# UNITED STATES PATENT AND TRADEMARK OFFICE

APPLICATION NO.	FILING DATE	FIRST NAMED INVENTOR	ATTORNEY DOCKET NO.	CONFIRMATION NO.
10/597,814	12/05/2006	Donald John Newman	10399.17	6648
21999 7590 07/07/2010 KIRTON AND MCCONKIE 60 EAST SOUTH TEMPLE, SUITE 1800 SALT LAKE CITY, UT 84111				
EXAMINER				
LUGO, CARLOS				
ART UNIT		PAPER NUMBER		
3673				
MAIL DATE		DELIVERY MODE		
07/07/2010		PAPER

# Office Action Summary

### DETAILED ACTION

attachment #1

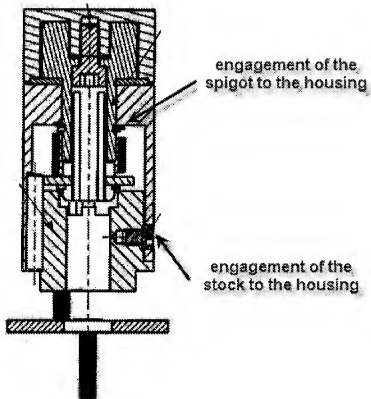
As to the 112 2<sup>nd</sup> paragraph rejection, the arguments are not persuasive and the rejection is maintained. The rejection was to claims 1 and 13. As seen in attachments #1 and #2, the housing is a cylinder having an open end and an opposed end. The opposed end has a front and an internal surface. A channel or hole is provided to communicate both surfaces.

The spigot tail is introduced into the hole and the spigot is secured to the housing by using a spring clip 26 that rest on the internal surface of the housing, not to the end of the housing.

Also, the mounting stock is introduced into the open end so that the stock can be attached to the housing by using a screw through an opening on a sidewall of the housing, not the end.

At the instant, in order to speed the process, the examiner suggest that the applicant should define the housing as explained in the 112 2<sup>nd</sup> paragraph section above, that is a cylinder having an open end and an opposed end. The opposed end has a front and an internal surface. A channel or hole is provided to communicate both surfaces and that the spigot tail is introduced into the hole and the spigot is secured to the housing by using a spring clip 26 that rest on the internal surface of the housing and the stock is introduced into the housing and secured to the housing using a securing means (screw) though a hole in the sidewall of the housing (see the attachments).
